# PRELIMINARY INFORMATION SHEET

PROJECT NAME: BENNINGTON  
 PROJECT NUMBER: ER BHF 010-1(45)  
 FILE NAME: z11b326\_pl.xls PLOT DATE: 8/21/2012  
 PROJECT LEADER: DEG DRAWN BY: KJK  
 DESIGNED BY: BTH CHECKED BY: SAW  
 PRELIMINARY INFORMATION SHEET SHEET 2 OF 40

THIS PROJECT INVOLVES THE RETROFITTING OF THE VERMONT ROUTE 9 BRIDGE 9 PIER FOUNDATIONS WITH MICROPILES IN THE TOWN OF BENNINGTON. THIS PROJECT DOES NOT INCLUDE ANY BRIDGE OR ROADWAY PAVEMENT REHABILITATION. THIS PROJECT WILL INVOLVE THE CONSTRUCTION OF TWO TEMPORARY ACCESS ROADS FROM VERMONT ROUTE 9 TO EITHER BRIDGE PIER.

Project Bennington ER BHF 010-1(45) Calculation Sheet Number \_\_\_\_\_  
 Line Item # 521.34 Page Number \_\_\_\_\_ of \_\_\_\_\_  
 Item # 0170 Field Measured by \_\_\_\_\_  
 Item Description CONCRETE, HIGH PERFORMANCE CLASS B  
 Location BRIDGE 9, PIER #1 FOOTING Date \_\_\_\_\_

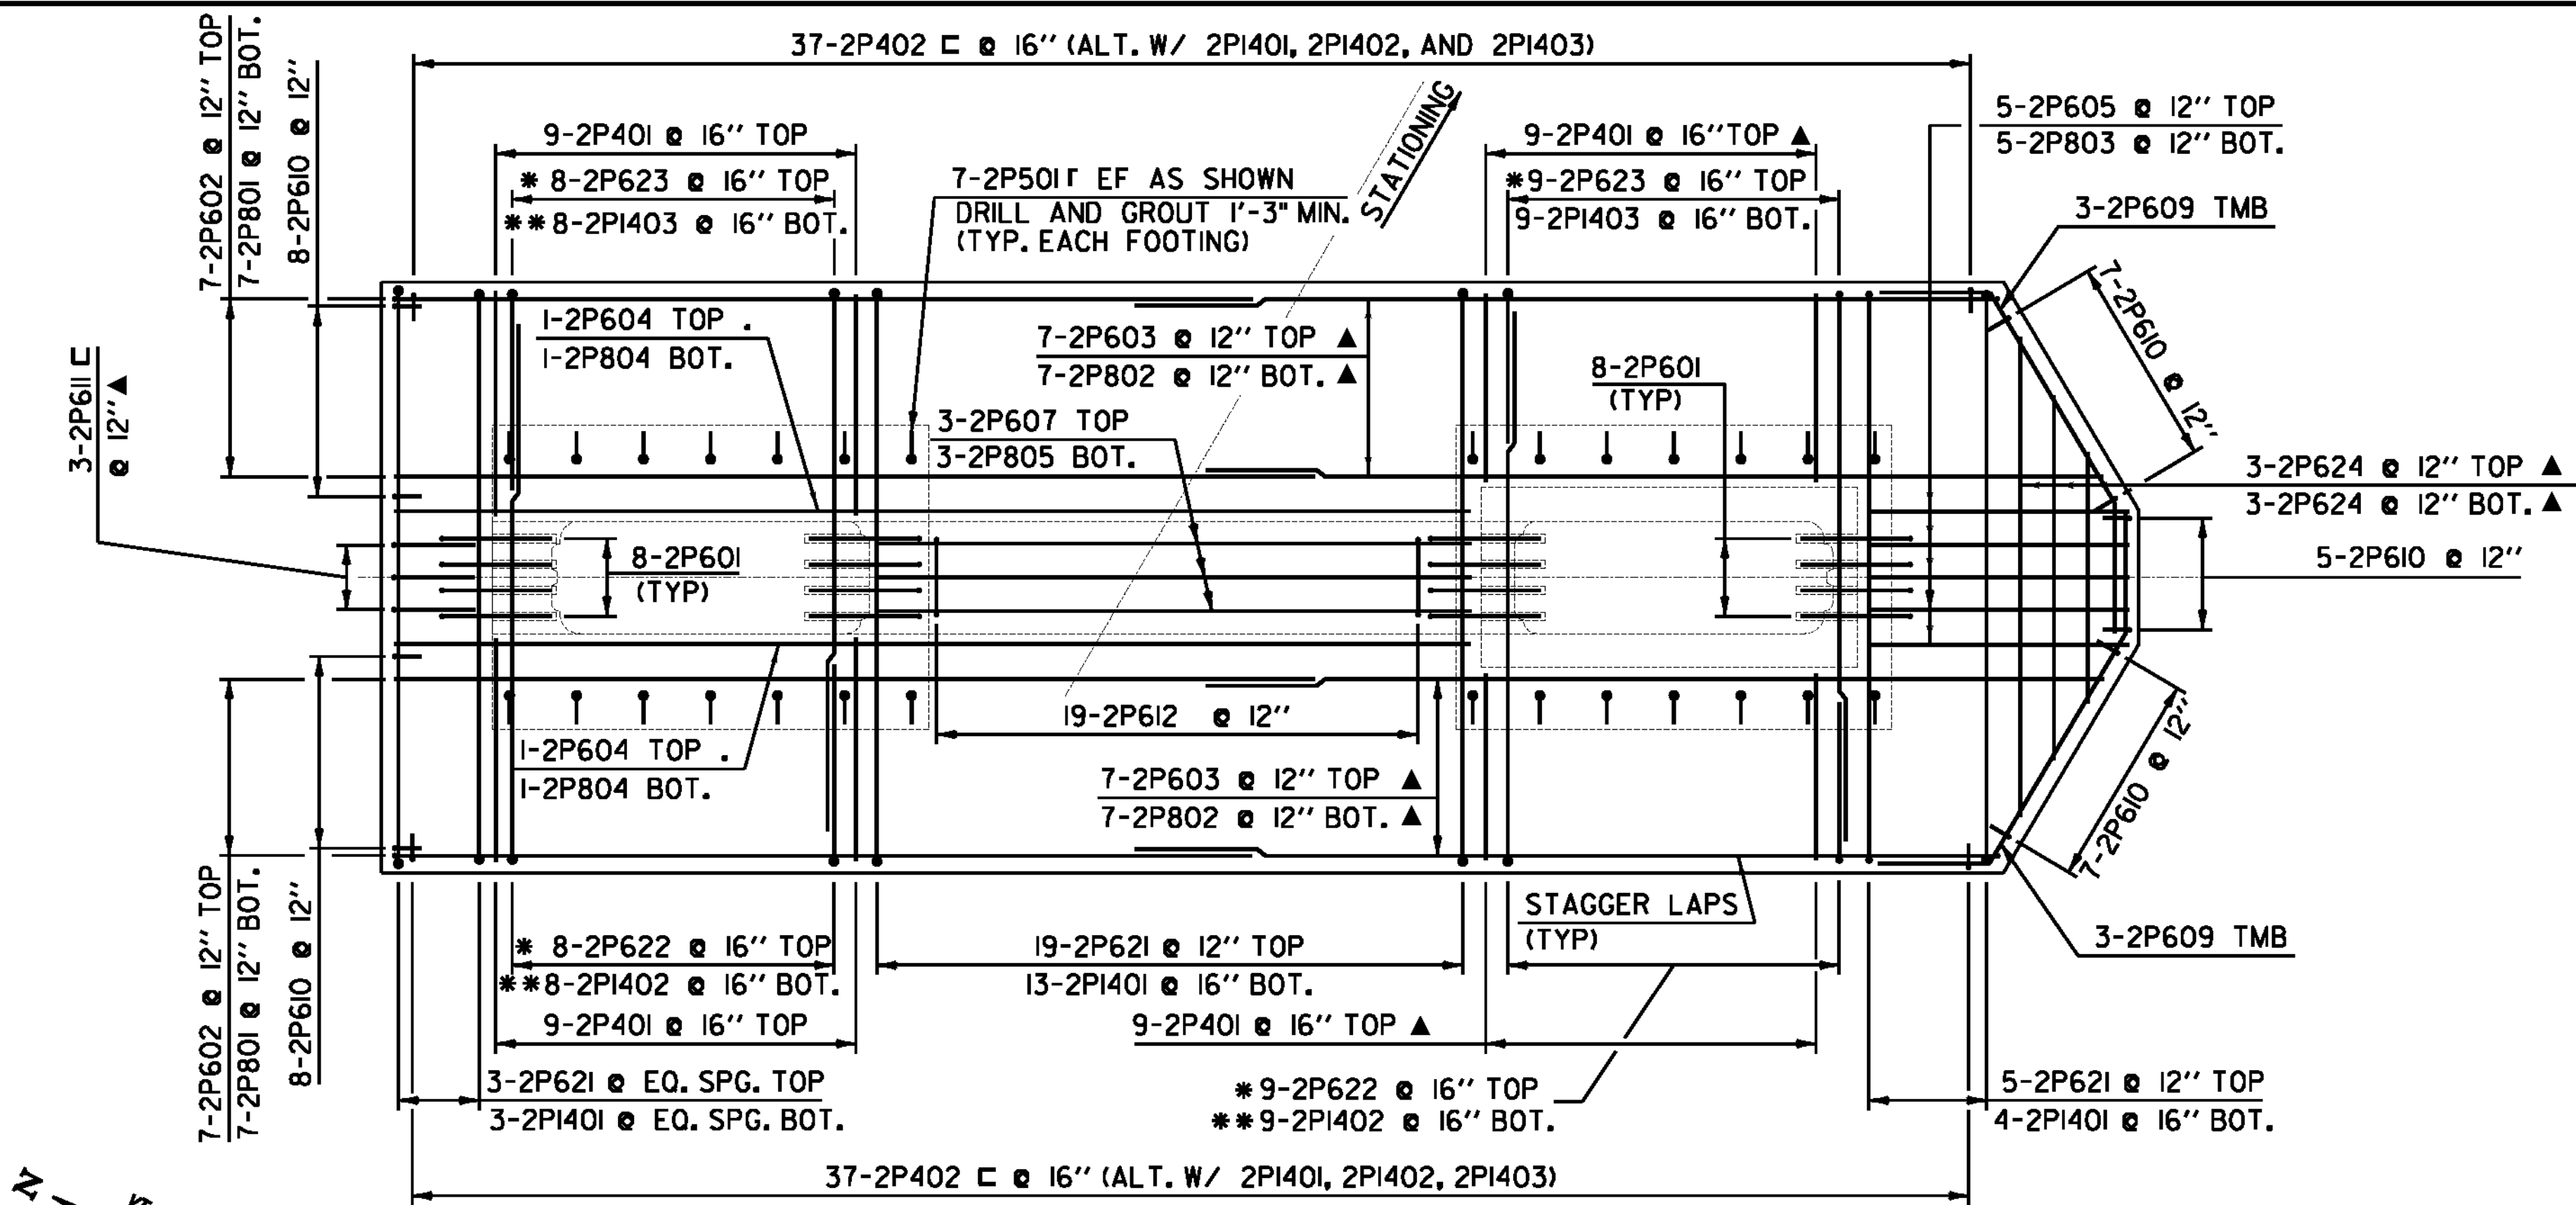
THE CONTRACTOR GRADED THE AREA BETWEEN THE EXISTING NORTH AND SOUTH FOOTINGS PER THE SKETCH BELOW. THE VOLUME UNDERNEATH THE WEB WAS NOT DEDUCTED IN THE COMPUTATION PREPARED ON 3-21-13 THEREFORE THE DEDUCTION MADE ON THIS SHEET.

LENGTH OF WEB BETWEEN THE EXISTING NORTH & SOUTH FOOTINGS = 15.65'  
 VOLUME TO BE DEDUCTED =  $3.33' (15.65') (1.0') / 27 = 1.93 \text{ cy.}$   
 REVISED TOTAL VOLUME =  $121.69 \text{ cy} - 1.93 \text{ cy} = 119.76 \text{ cy.}$

Pay 119.76 cy. FINAL

**PIER 1 SECTION A-A**  
SCALE: 1/2" = 1'-0"

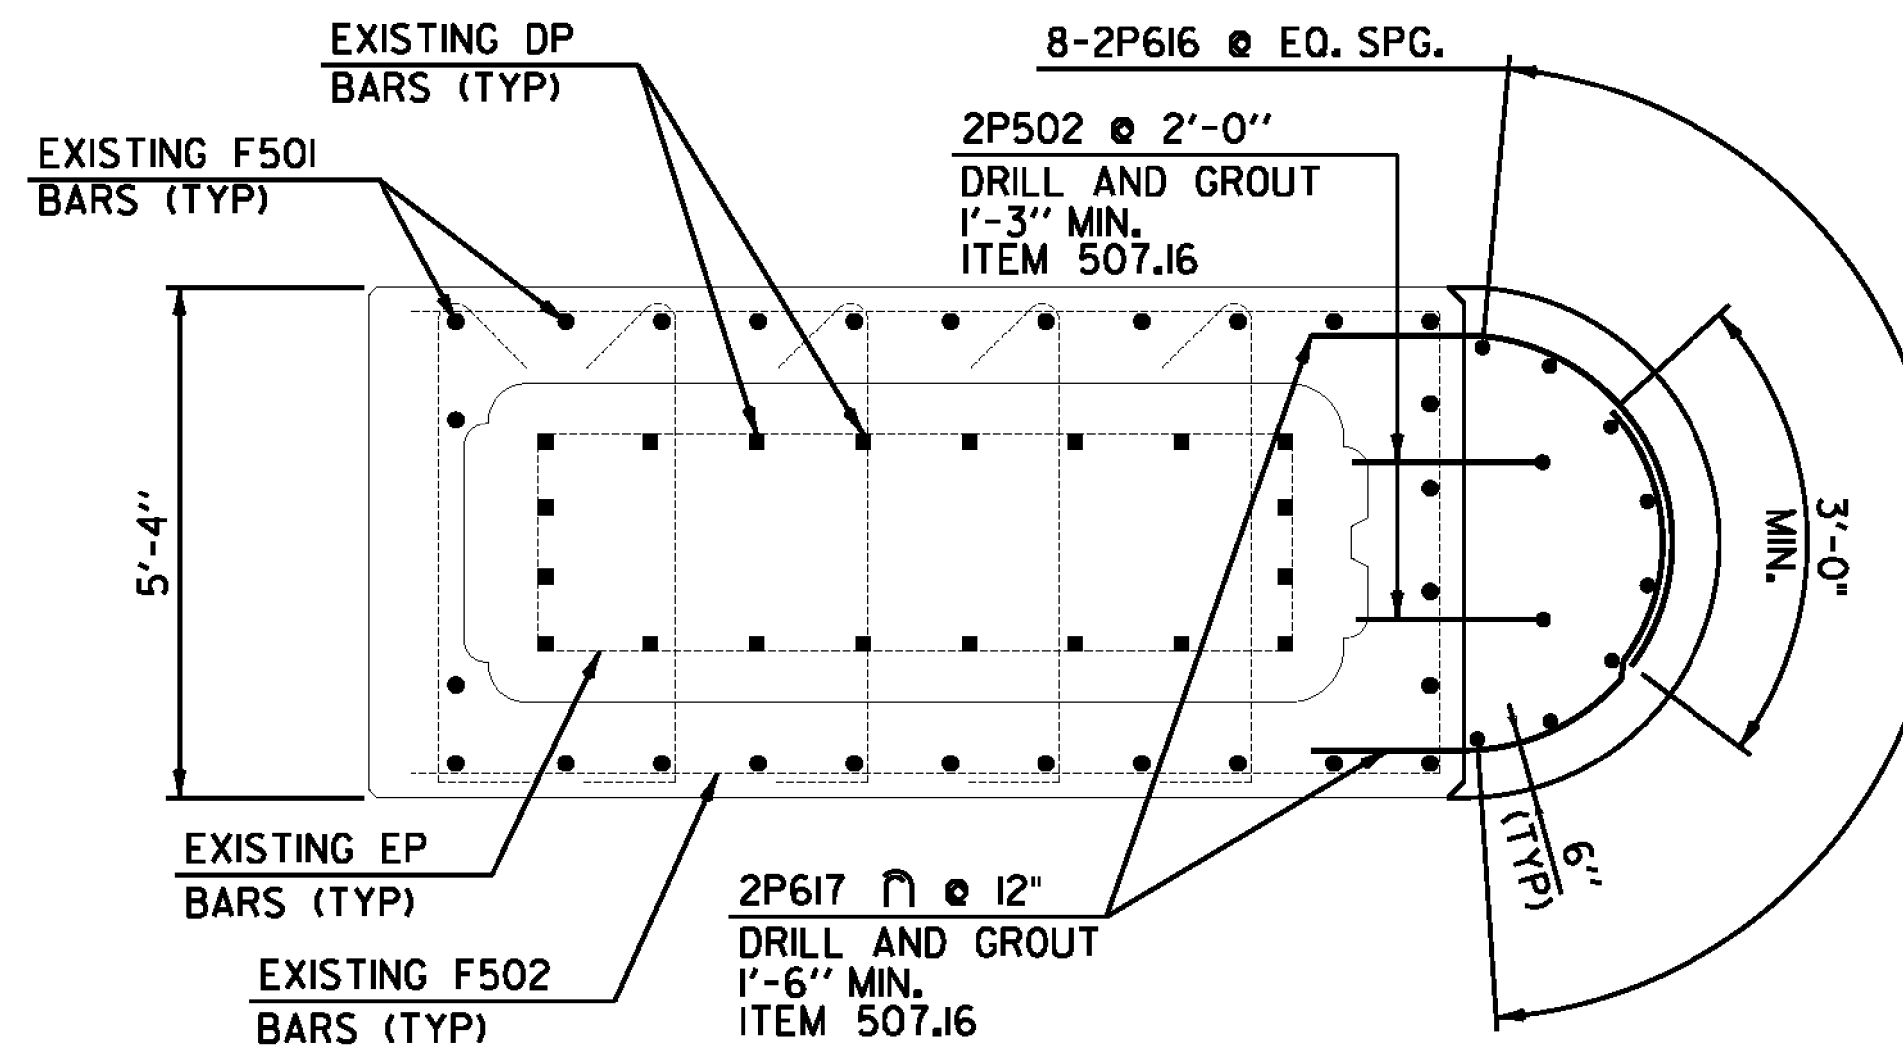
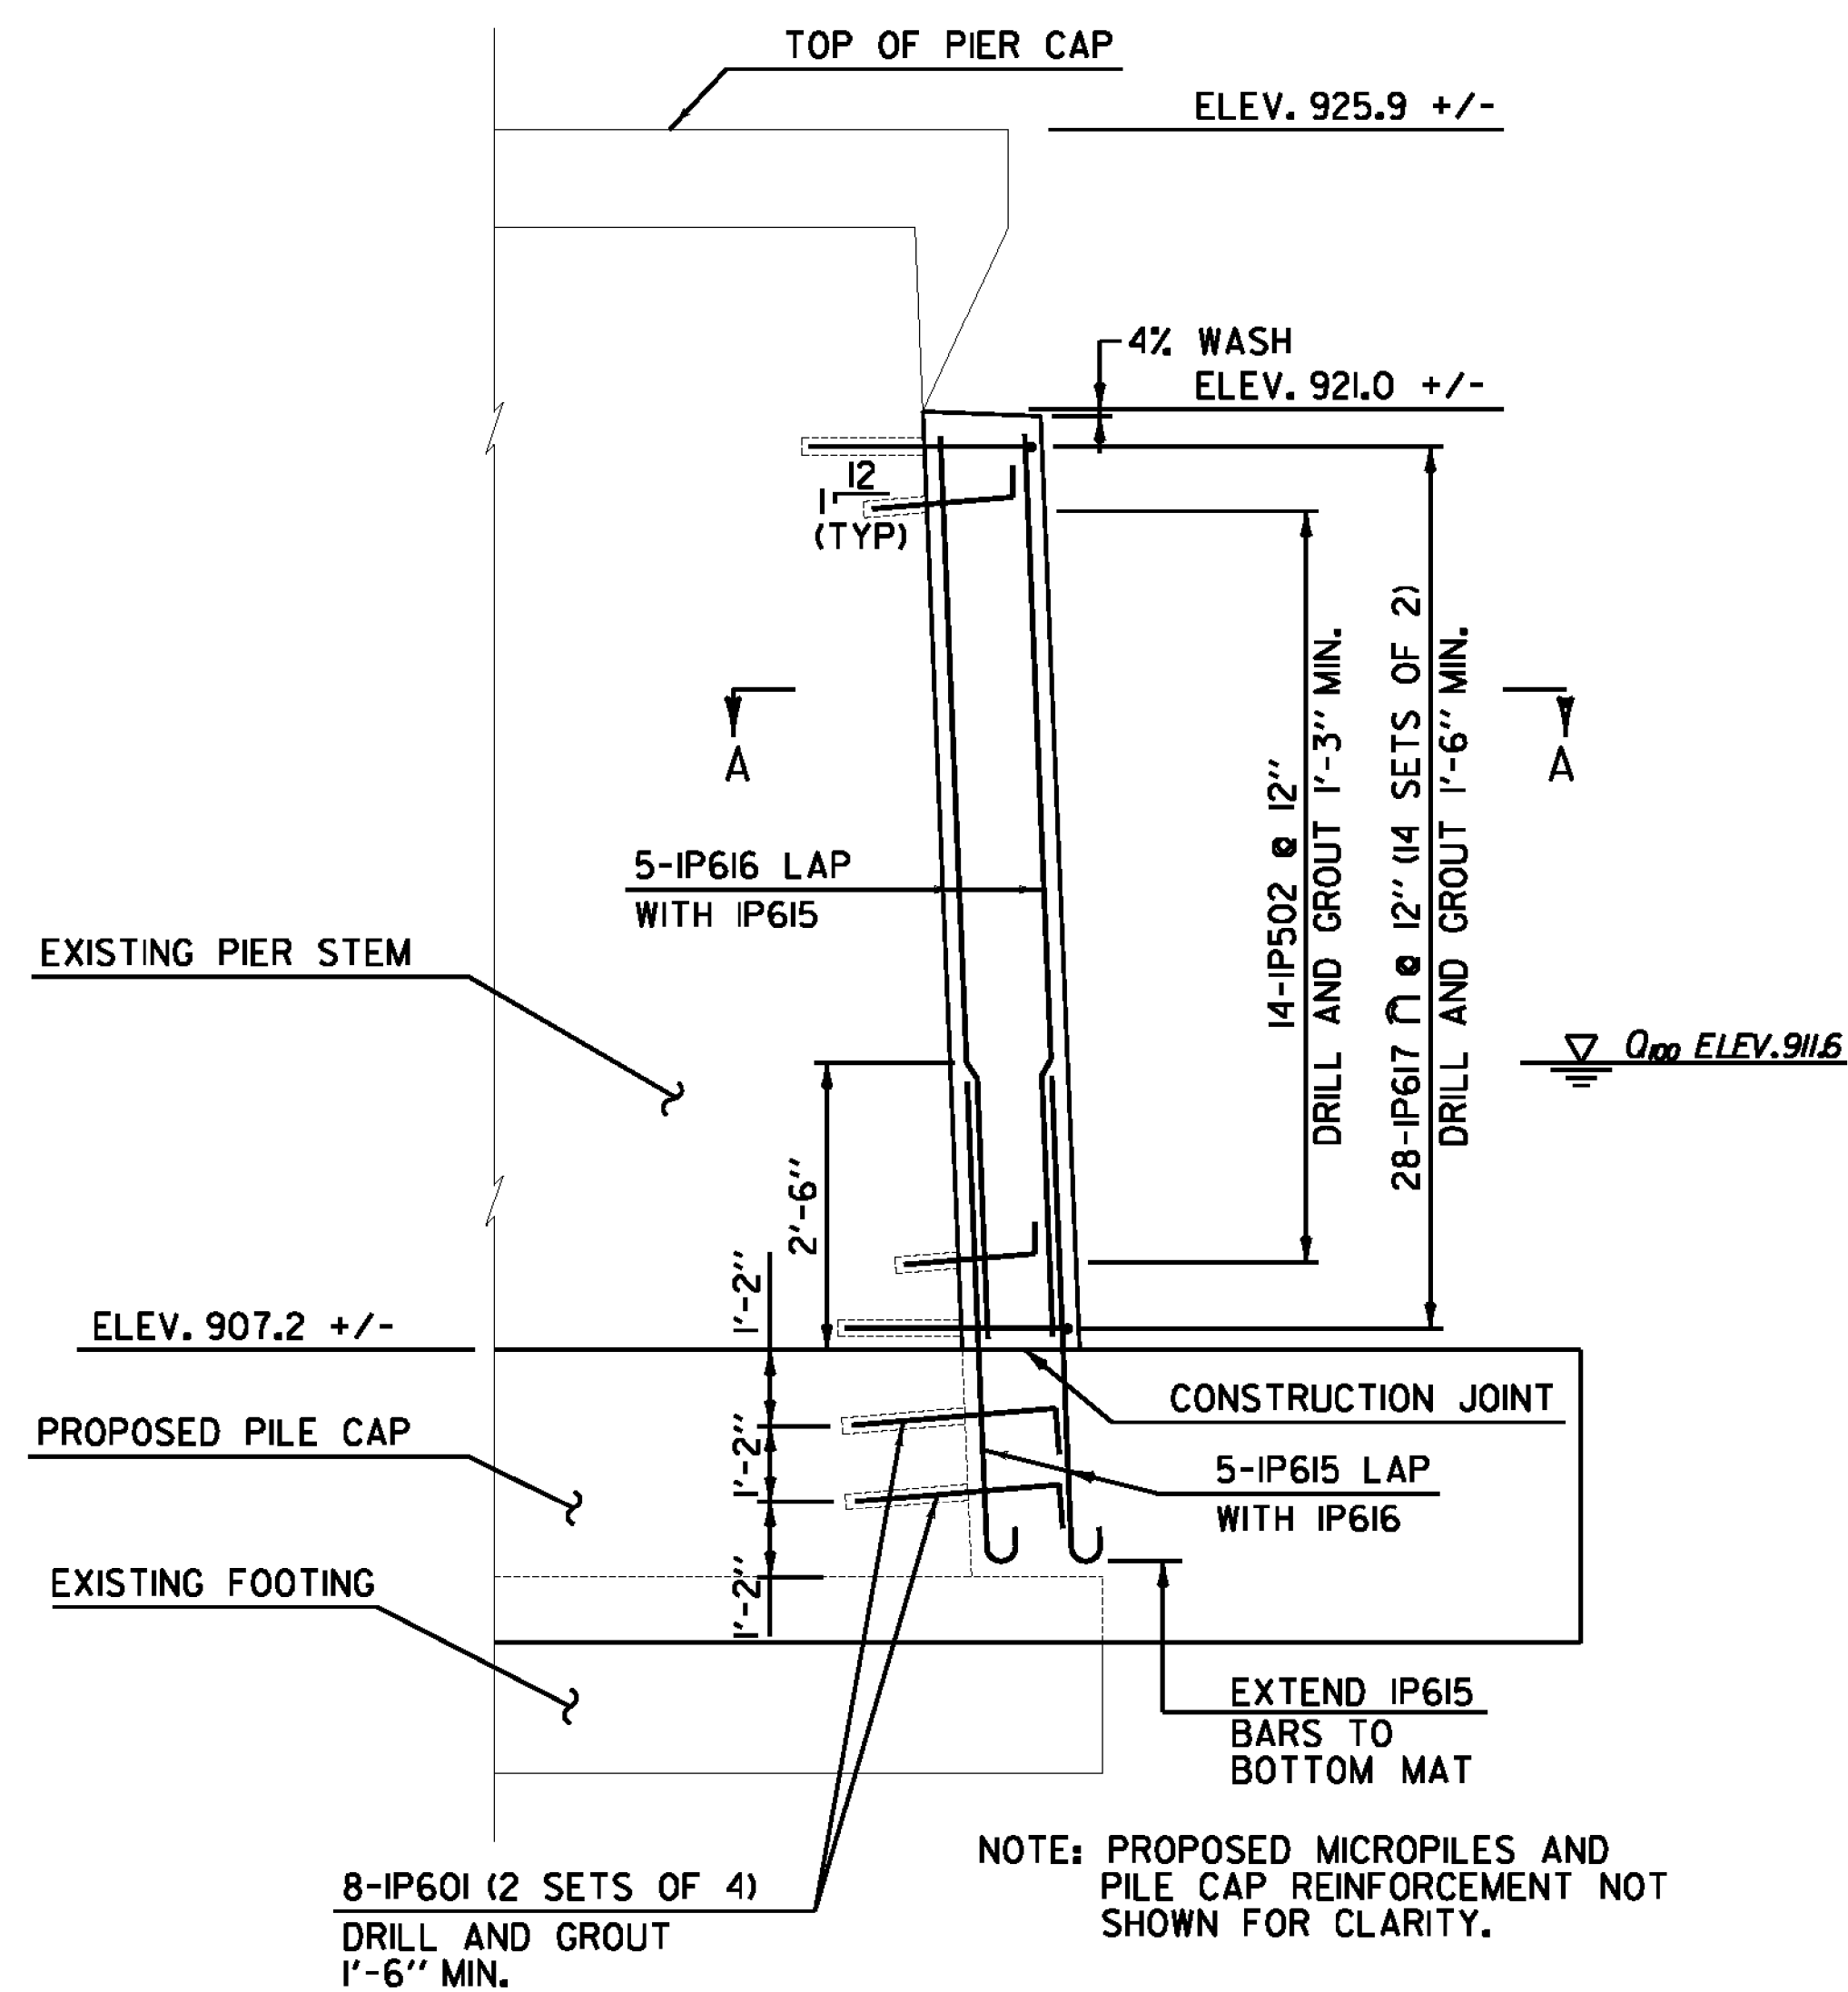
CONSTRUCTION JOINT  
MODIFIED PER C.O. #2

AS BUILT PIER #1 NOLING DETAIL

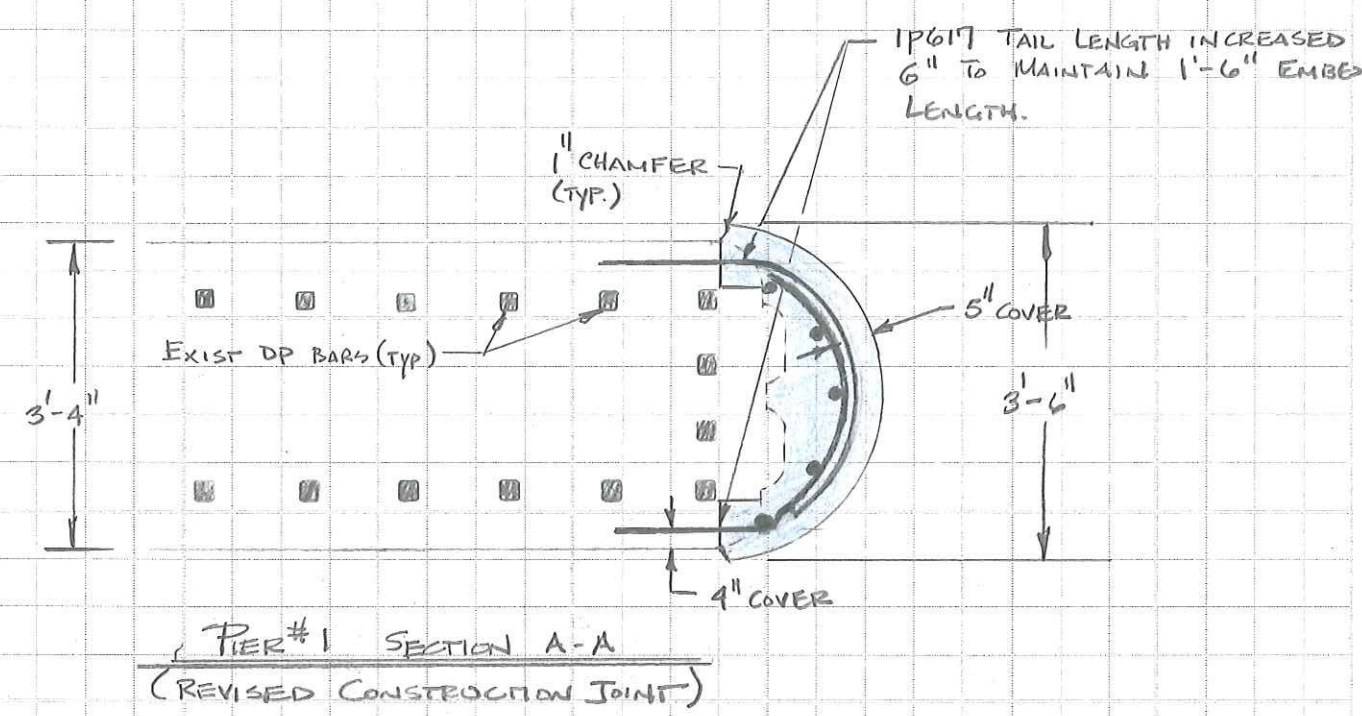
PIER #1 SECTION A-A  
(REVISED CONSTRUCTION JOINT)

THE CONTRACTOR WAS ALLOWED TO USE A 42" DIA CAN TO FORM PIER #1  
 NOLING. PREVIOUS THE EDGE AT THE CONSTRUCTION JOINT IS CHAMFERED.  
 ADDITIONAL CONCRETE WAS REQUIRED AT THE CONSTRUCTION JOINT TO  
 ELIMINATE THE ACUTE ANGLE AS SHOWN IN THE ORIGINAL SECTION PER CO. #2.  
 THE BARS MARKED IPG11 WERE ADJUSTED TO ENSURE THE MIN EMBEDMENT  
 LENGTH OF 1'-6" WAS NOT COMPROMISED.
